**Re: Indian Point Unit No. 2  
Docket No. 50-247**

**Subject: NEI Pilot Program for Use of NUREG-1465**

**Responses to Requests for Additional Information  
Received from the Regulatory Staff**

**Responses to Requests for Additional Information**  
**Received from the Regulatory Staff**

**Figure 1**

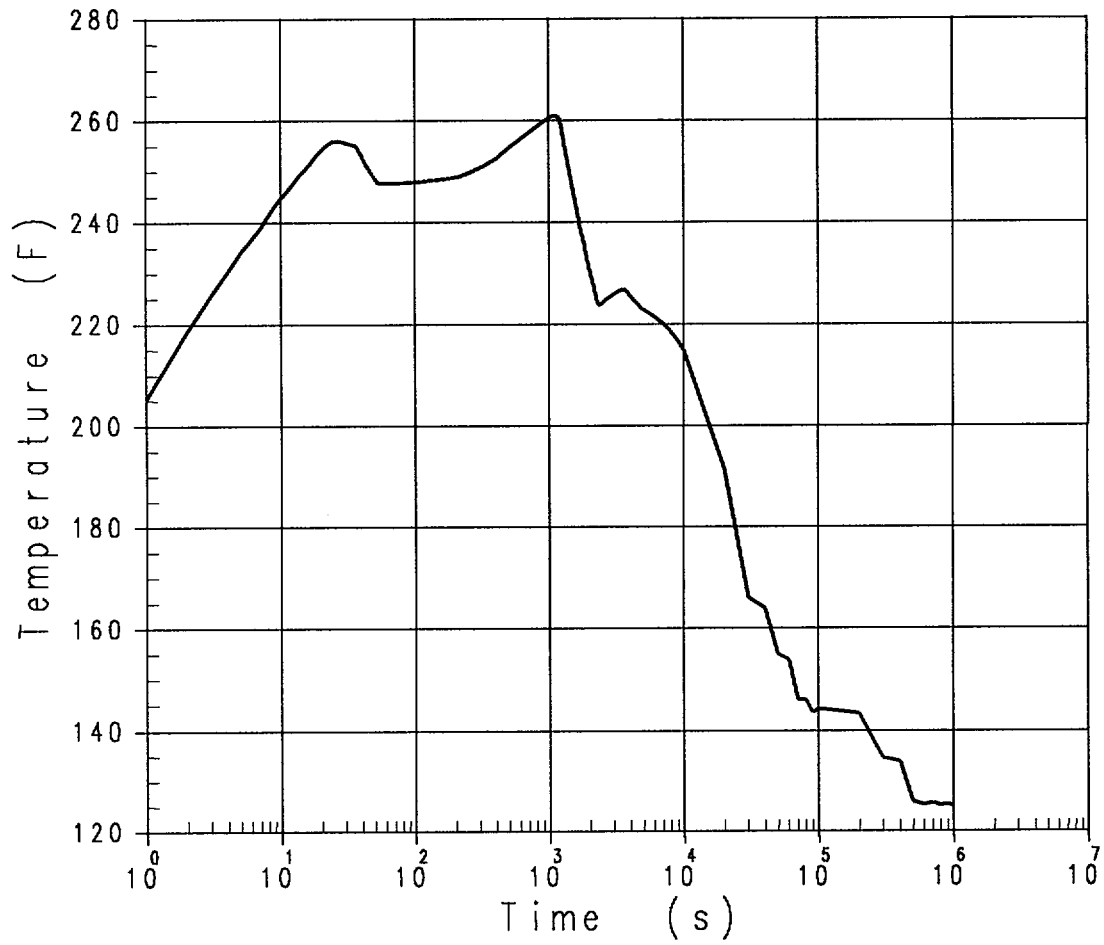
Provide an analysis of the control room and offsite radiological doses for the design basis loss of coolant accident which includes the contribution from potential external ECCS leakage post accident.

4. Containment sump water temperatures have been recalculated to more accurately define the conditions at extended periods post accident. These replace the values currently in the UFSAR. These temperatures are provided in Figure 1.
